## 21 LOCAL AGENCIES

**Palmdale - Burbank - RECORD #4045 DETAIL**

Figure 1. Aerial photograph showing wildlife movement opportunities, looking north from Agua Dulce Canyon Road, through the Linkage Design, across the SR 14 freeway corridor with UC Davis Wildlife-Vehicle Conflict Hotspots identified.

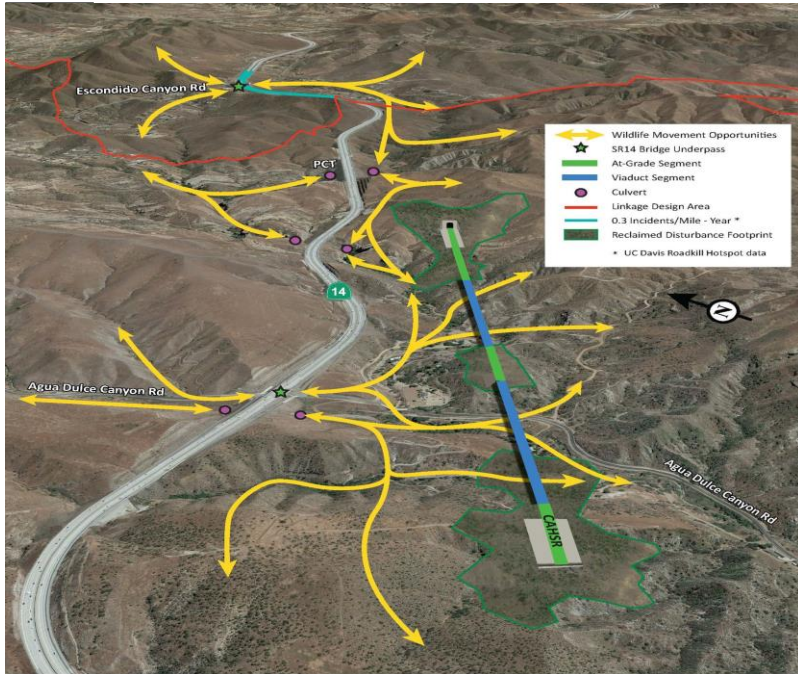
volumes (cited below), and the steep road cuts and natural terrain (see Figure 3 and 4 below). This is confirmed by the lack of wildlife-vehicle conflict occurrences adjacent to Bee Canyon between Stonecrest Road and Agua Dulce Canyon Road. Substantial evidence developed for the WCA indicates that the approximately 1-mile stretch of the SR 14 freeway adjacent to Bee Canyon is a complete barrier to movement. The 2014 annual average daily traffic volume (AADT) for the SR 14 freeway ranges between 71,000 and 99,000 vehicles in Palmdale and Santa Clarita (Caltrans 2014), which is seven to ten times the volume that Clevenger and Huijser (2009) found to repel wildlife due to the almost constant level of disturbance and heavy traffic volume. In addition, the steep road cuts and steep terrain along the SR 14 freeway, between Stonecrest Road and Agua Dulce Canyon Road, make the freeway less likely to facilitate wildlife movement as highlighted in the UC Davis roadkill data. Examples of the steep road cuts are provided in the Google Streetview images below.

Figure 2-53 Burbank Airport Station Preliminary Station Concept Layout Plan

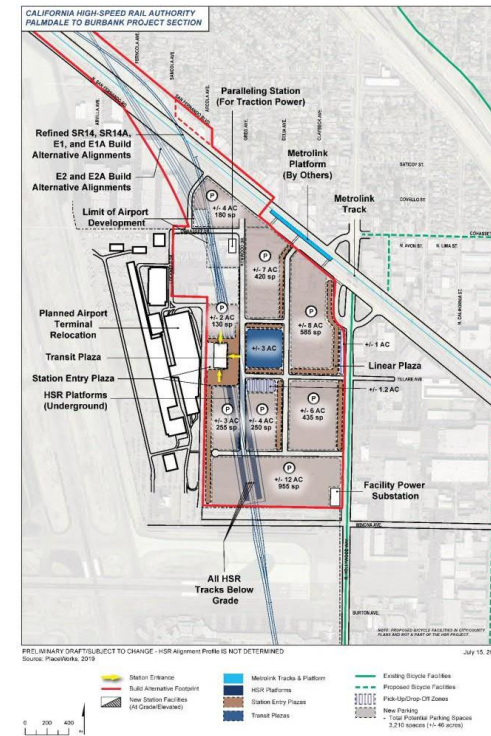
- Page 2-103, Section 2.5.3.1 and page 2-105, Figure 2-53: Although not Airport property, it is important to note that the current land associated with a large portion of the station site and its associated surface parking spaces as depicted in

Figure 2-53 has undergone a significant amount of construction since Figure 2-53 was created. As a result, the description of the area is no longer accurate.

1. The plan layout shown in Figure 2 below indicates the "build alternative footprint" of the CHSRA rail station occupying approximately 70 acres of surface property based on statements given in the Draft EIR/EIS for Palmdale to Burbank Chapter 4 (section 4.4.8.1, page 4-23).
2. Burbank Airport Station is planned to have up to 3,210 surface parking spaces by 2040 with 1,640 spaces operational when the rail system starts up as projected to be 2029.
3. The planned Burbank Airport Station is shown to be directly adjacent to the Planned Airport Terminal Relocation to the west.

The commenter notes changes to the existing land use conditions for a portion of the station site depicted in Section 2.5.3.1 and Figure 2-53 in Chapter 2 of the Draft EIR/EIS, to the east of the Hollywood Burbank Airport. The Authority believes this is a reference to the Avion Burbank development.

**Overview of Burbank Airport Station Preliminary Station Concept Layout Plan:**

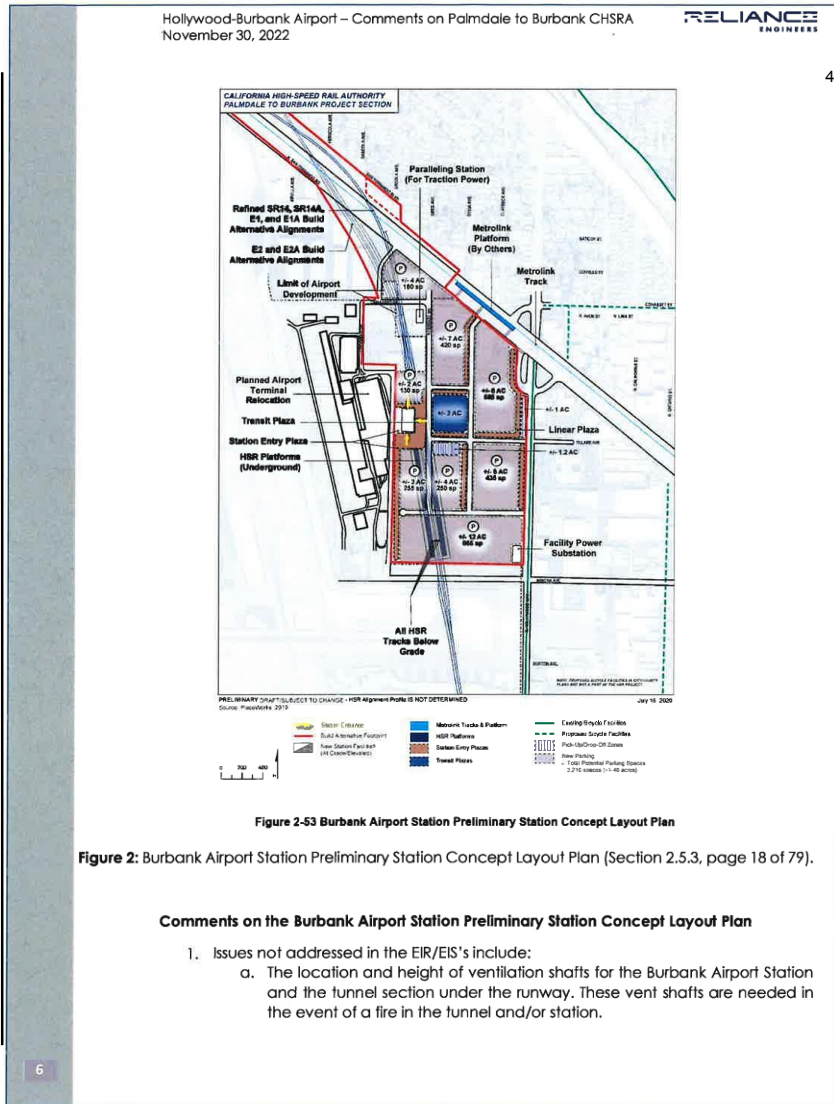
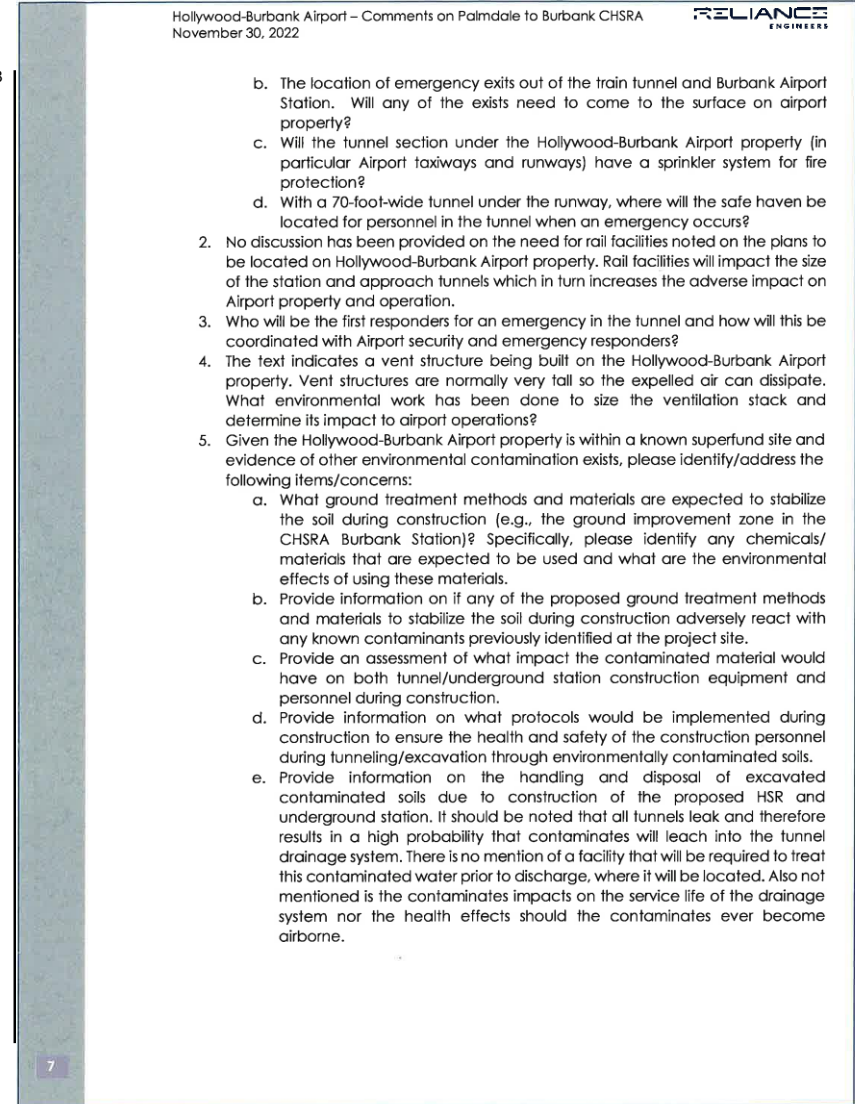
1. The plan layout shown in Figure 2 below indicates the "build alternative footprint" of the CHSRA rail station occupying approximately 70 acres of surface property based on statements given in the Draft EIR/EIS for Palmdale to Burbank Chapter 4 (section 4.4.8.1, page 4-23).
2. Burbank Airport Station is planned to have up to 3,210 surface parking spaces by 2040 with 1,640 spaces operational when the rail system starts up as projected to be 2029.
3. The planned Burbank Airport Station is shown to be directly adjacent to the Planned Airport Terminal Relocation to the west.
